The revision to the TSs makes changes to reflect the hardware modifications to facility and other items that are a part of the "Average Power Range Monitor, Rod Block Monitor and Technical Specification Improvement (ARTS) Program" for Edwin I. Hatch Nuclear Plant, Unit 1.

GEORGIA POWER COMPANY
OGLETHORPE POWER CORPORATION
MUNICIPAL ELECTRIC AUTHORITY OF GEORGIA
CITY OF DALTON, GEORGIA
DOCKET NO. 50-321
EDWIN I. HATCH NUCLEAR PLANT, UNIT NO. 1
AMENDMENT TO FACILITY OPERATING LICENSE

Amendment No. 105
License No. DPR-57

ATTACHMENT TO LICENSE AMENDMENT NO. 105

FIGURE 3.11-1 (SHEET 7) MAPFAC_F

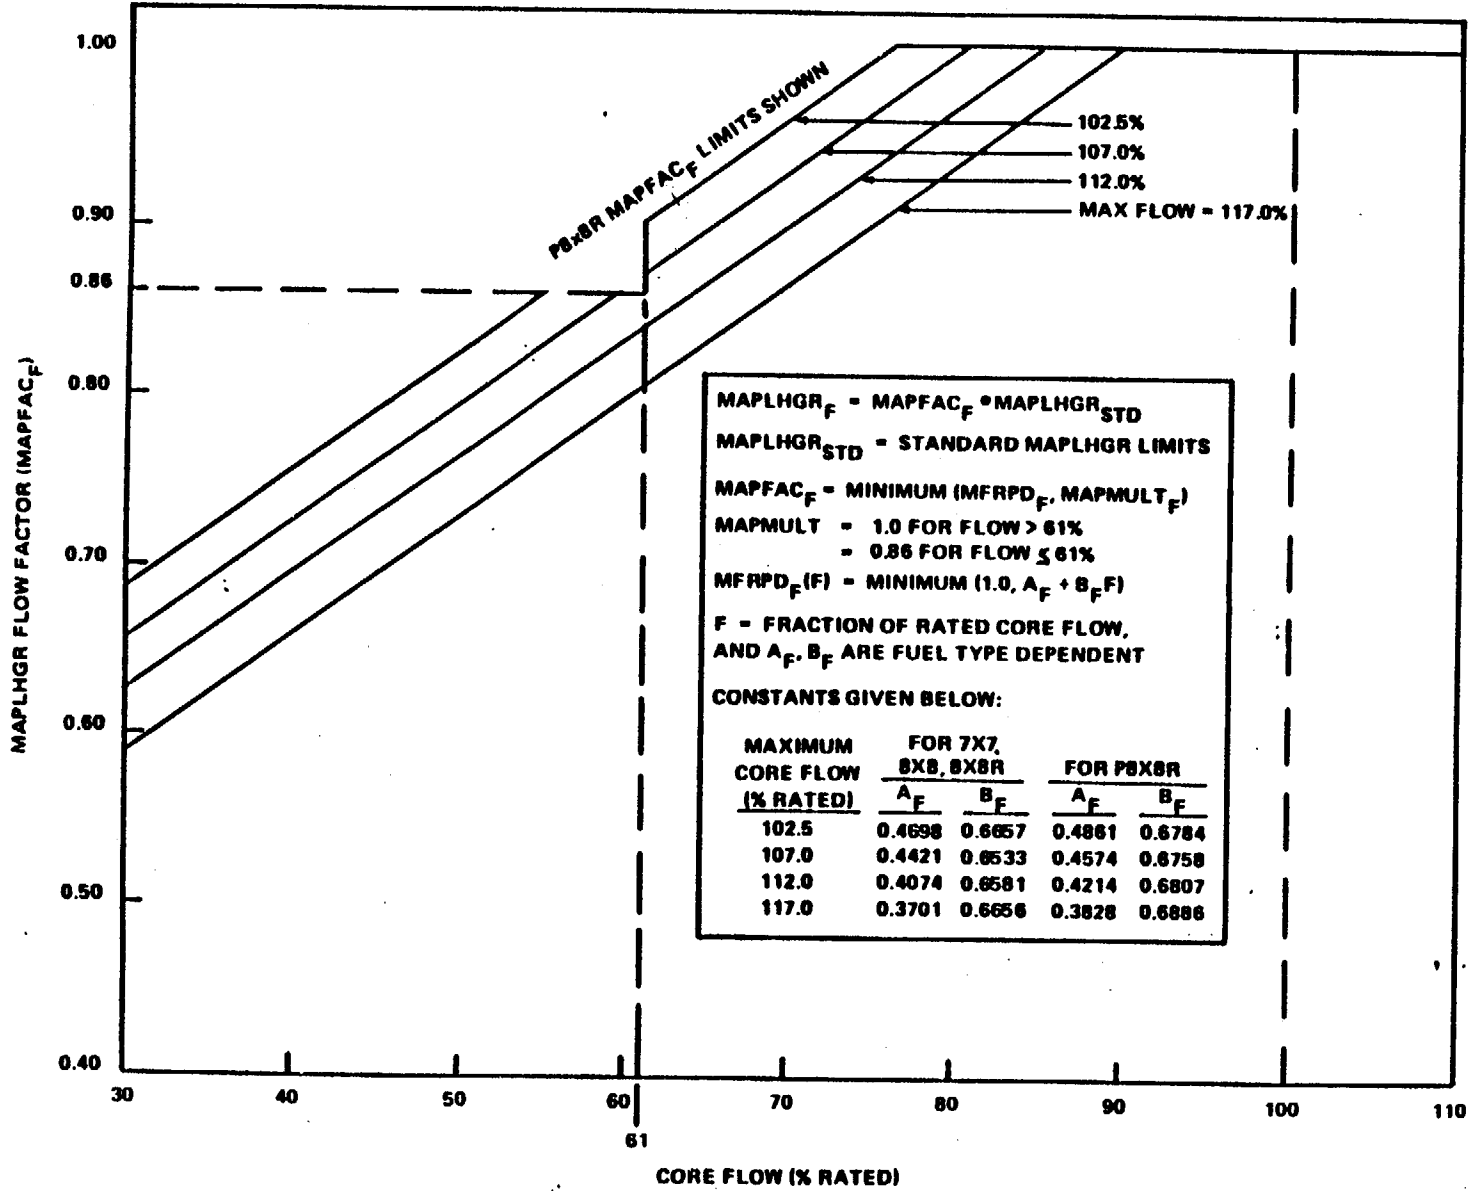
A flow dependent correction factor incorporated in to Figure 3.11-1 (sheet 7) is applied to the rated conditions APLHGR to assure that the 2200°F PCT limit is complied with during LOCA initiated from less than rated core flow. In addition, other power and flow dependent corrections given in Figure 3.11-1 (sheets 6 and 7) are applied to the rated conditions APLHGR limits to assure that the fuel thermal-mechanical design criteria are met during abnormal transients initiated from off-rated conditions.

FIGURE 3.11.3 MCPR_F

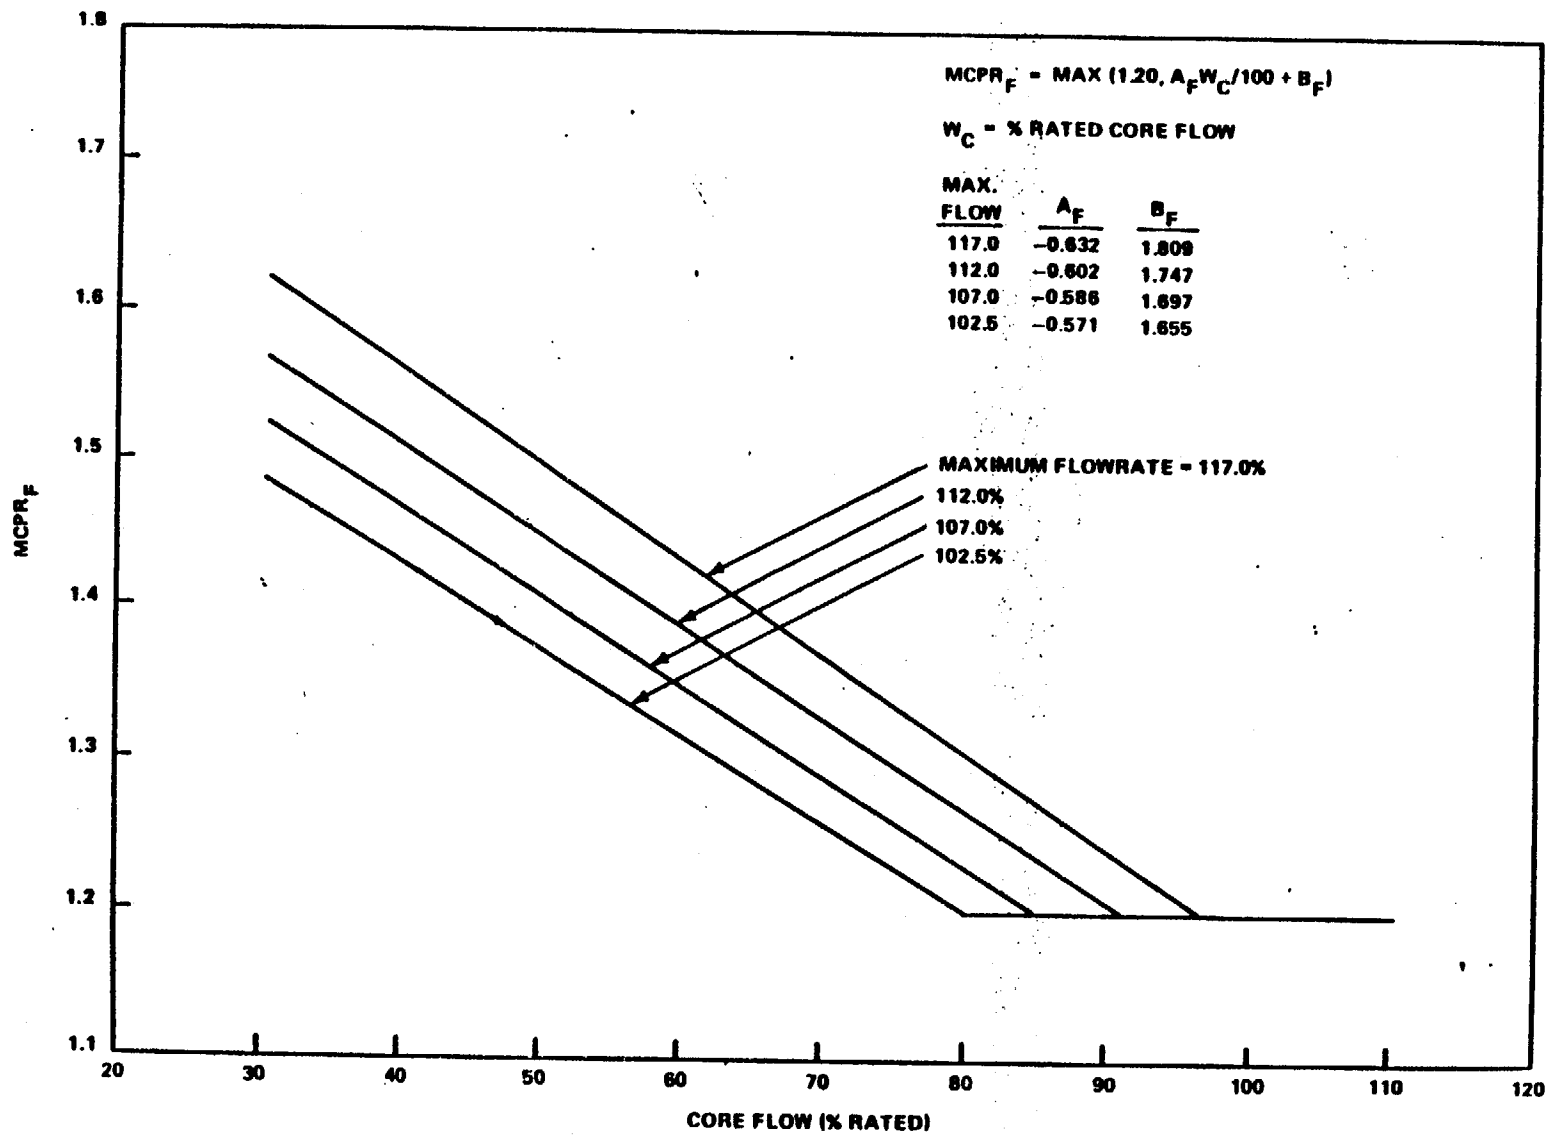
1. The applicable limit determined from Figure 3.11.3, or
2. The applicable limit from either Figures 3.11.4, 3.11.5, or 3.11.6, multiplied by the K_p factor determined from Figure 3.11.7, where:

FIGURE 3.11.7 K_p

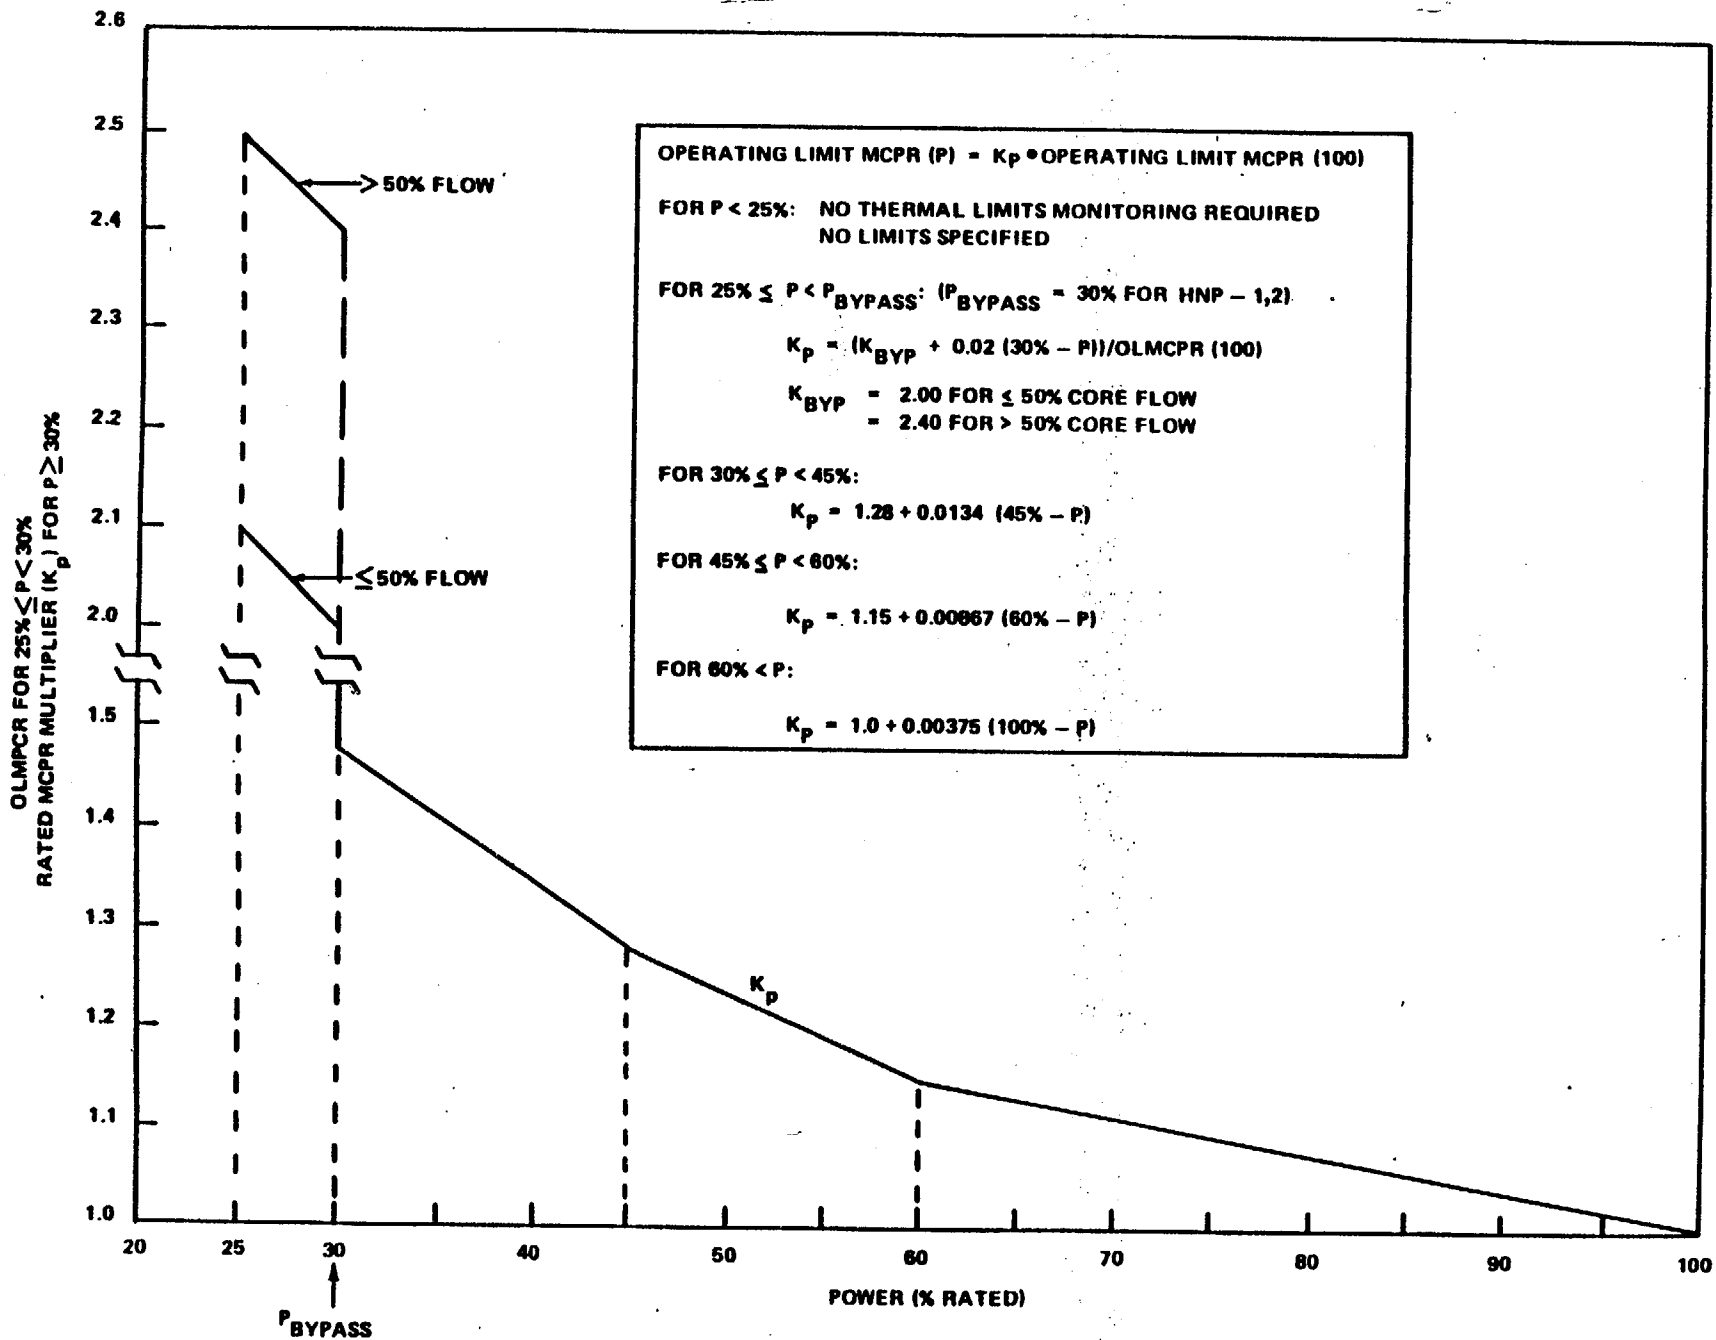
The minimum critical power ratio (MCPR) shall be equal to or greater than the operating limit MCPR (OLMCPR), which is a function of scram time, core power, and core flow. For 25% ≤ power < 30%, the OLMCPR is given in Figure 3.11.7. For power ≥ 30%, the OLMCPR is the greater of either:

The core power dependent MCPR operating limit $MCPR_p$ is the power rated flow MCPR operating limit multiplied by the K_p factor given in Figure 3.11.7.
